**Subject: Response to Portion of NRC Request for Additional Information  
Letter No. 26 Related to ESBWR Design Certification Application –  
Isolation Condenser – RAI Numbers 5.4-21, 5.4-23 through 5.4-26,  
5.4-28 through 5.4-30, 5.4-32 through 5.4-35, 5.4-38, 5.4-41, 5.4-42,  
5.4-44 through 5.4-46, 5.4-48, 5.4-50, and 5.4-52**

**MFN 06-249**

Isolation Condenser

## Appendix A

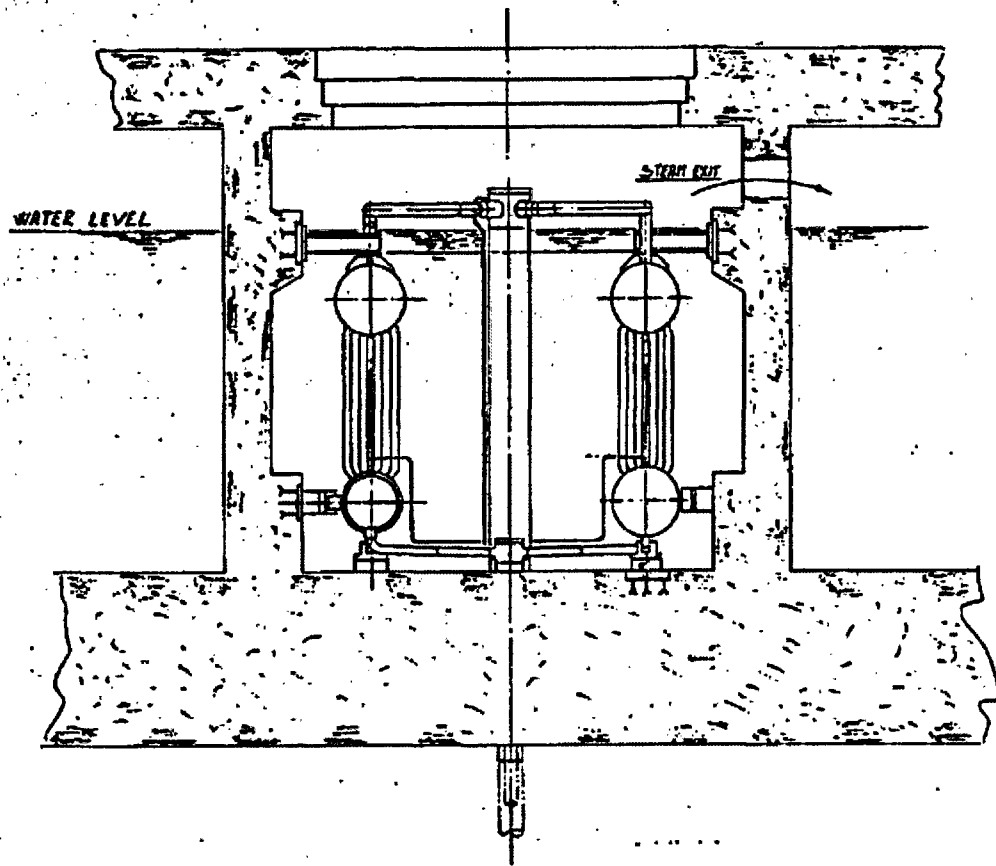
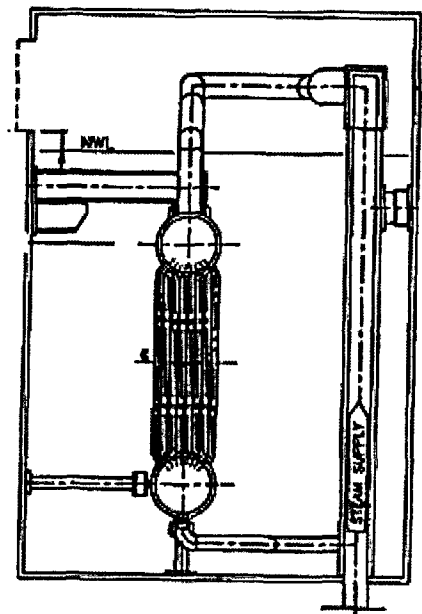
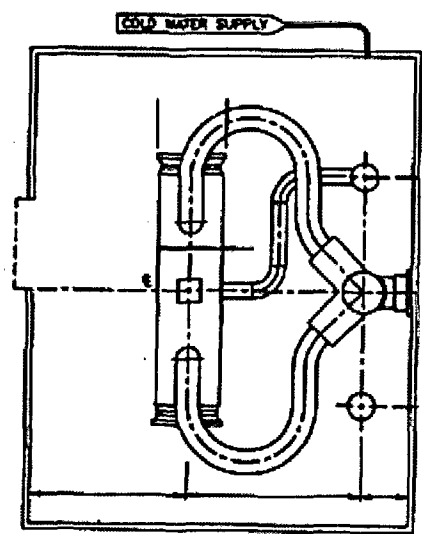
*The isolation condenser (IC) for the ESBWR is a vertical heat exchanger significantly different from operating plants' ICs. Provide the following: a detailed description of the heat exchanger, the heat transfer coefficient required for this heat exchanger, and a drawing of the ESBWR IC in DCD Tier 2.*

(C) Provide a Drawing of the ESBWR IC in DCD Tier 2

A schematic of the IC heat exchanger was provided to the NRC in the SEIT Panther ICS Test Report. In Appendix A of this letter is a copy of the schematic found in the Panther Test Report and an ANSALDO P&ID. A drawing of the IC will not be included in Tier 2 of the DCD.
